Case 8300A-11

Exterior Lighting Compliance Certificate

Energy Code: 2012 IECC
Project Title: Countryside Shopping Center
Project Type: Alteration
Permit No. TBD
Exterior Lighting Zone: 4 (High activity metropolitan commercial district)

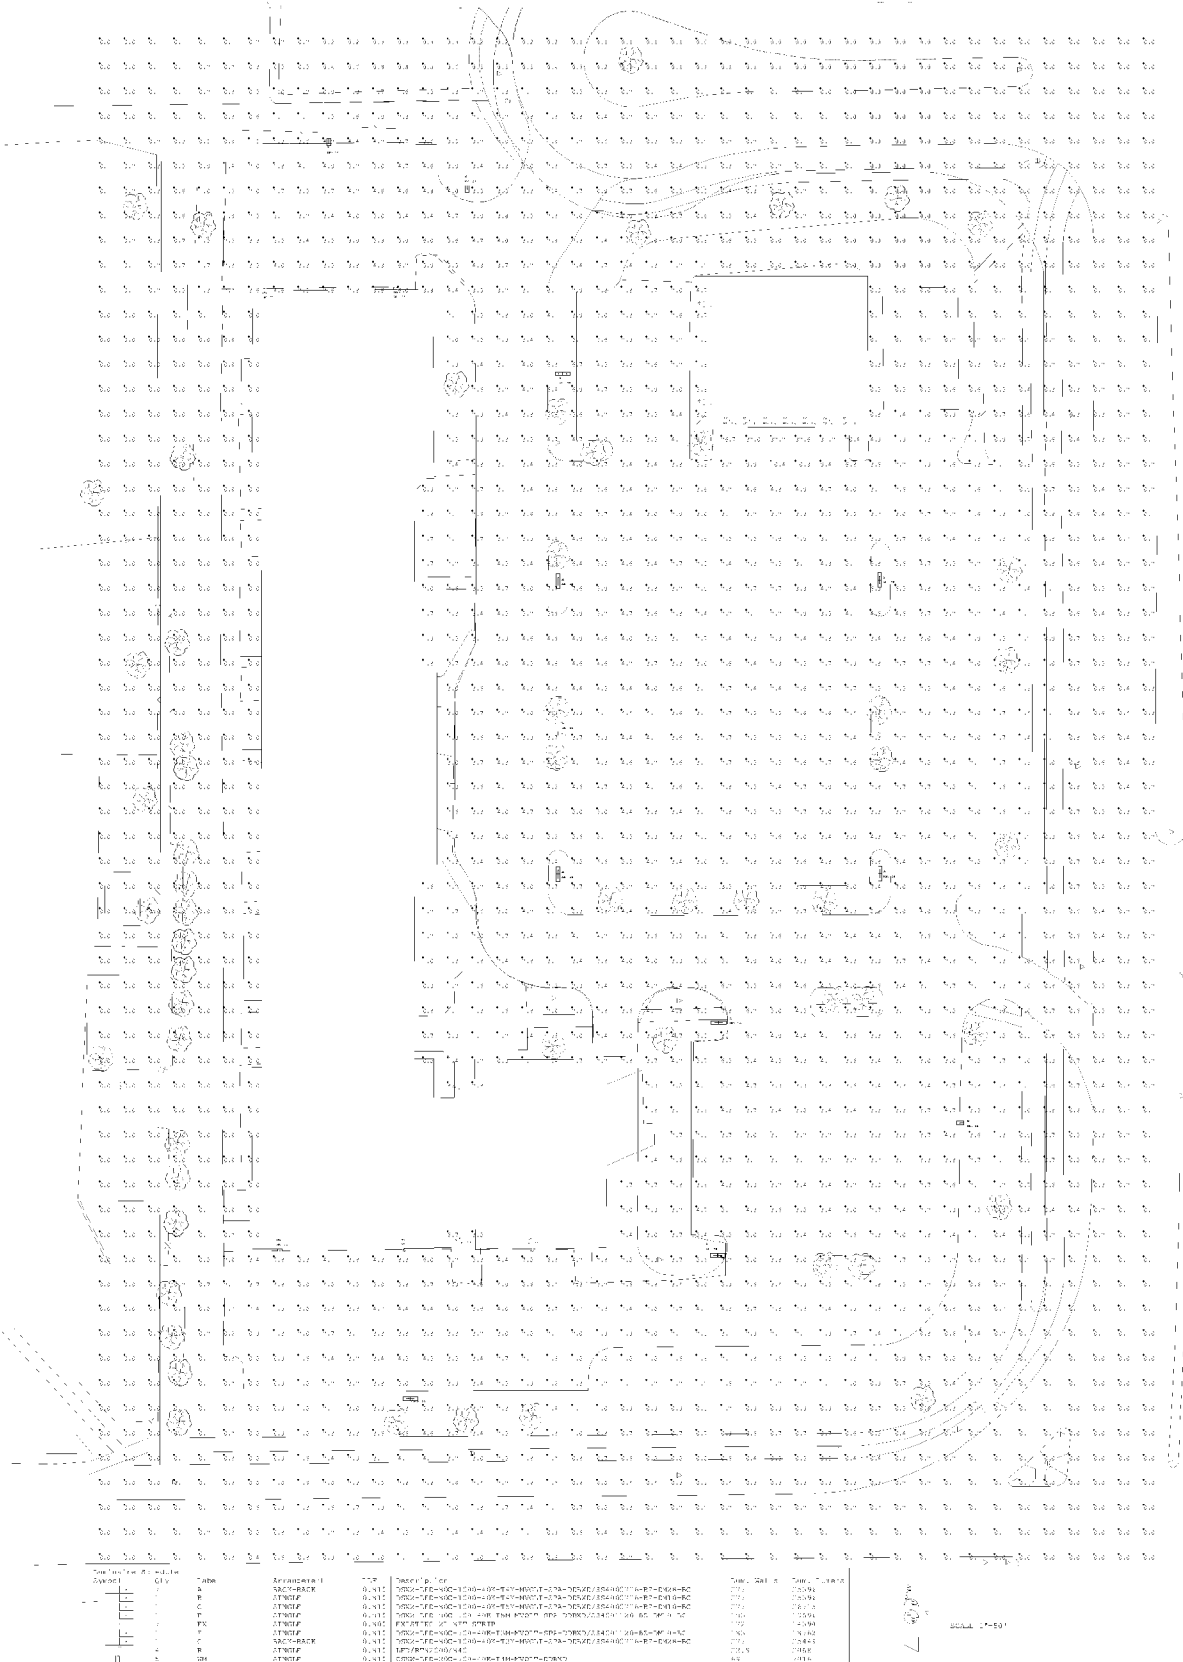
- 1) Code requires post install inspection.
Call 952-563-8920 to schedule.
- 2) No change in fixture allowed without
a revised plan review and approval.
